### MEMORANDUM

RE: ZP 14-0405CA; 121 North Willard Street

**Request:** Convert 2<sup>nd</sup> floor of existing carriage barn into a one bedroom apartment; increasing the number of residential units on the site from one to two. Revision of proposed parking, request for a one-space parking waiver.

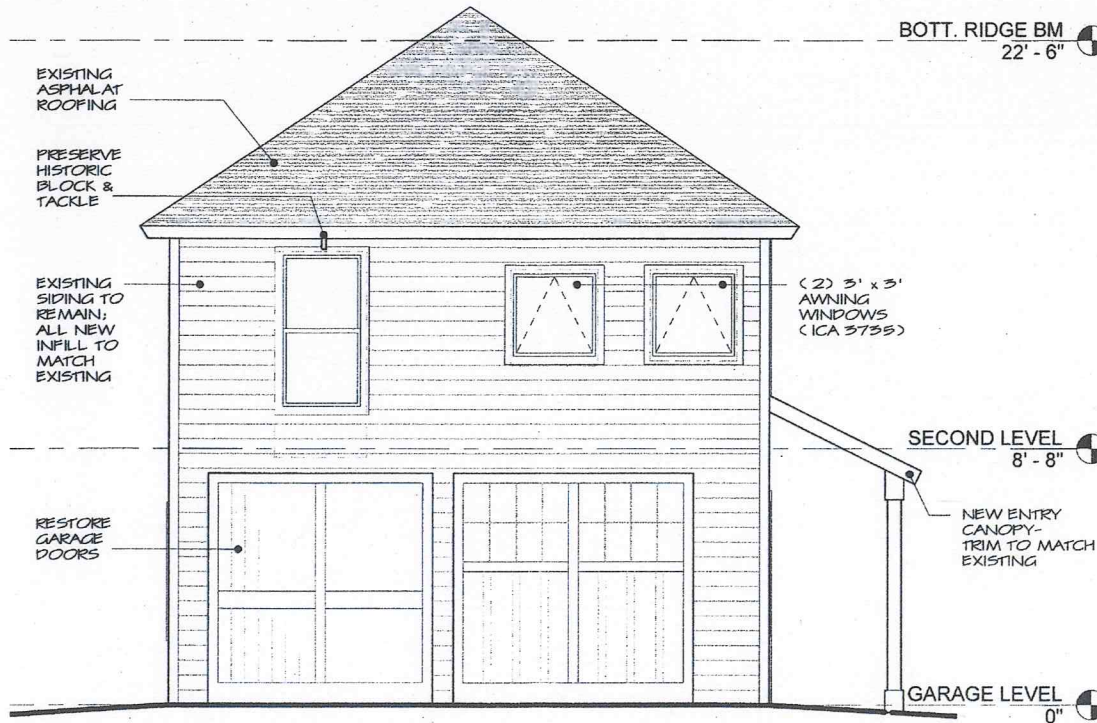
This 2004 orthophotograph with parcel boundaries illustrates that 121 North Willard (center) has no setback from the northerly property boundary, a situation repeated in adjacent parcels on both sides.

① SITE PLAN  
1" = 10'-0"

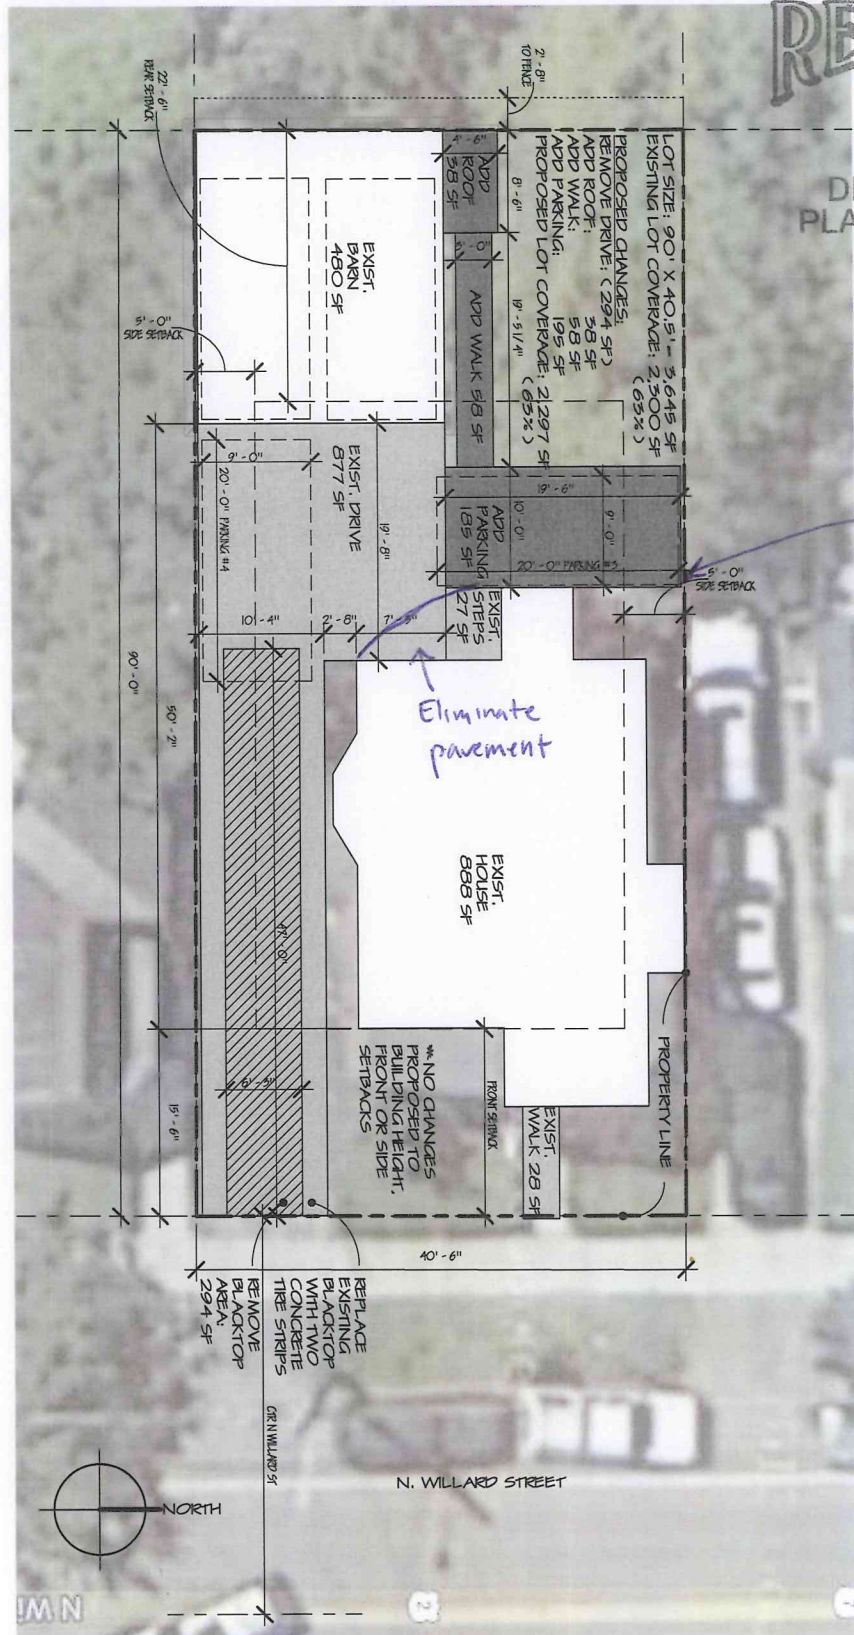
- Pull parking space  
2' off house,  
1' setback from  
property line &  
add hedge in  
front of spot

Eliminate pavement
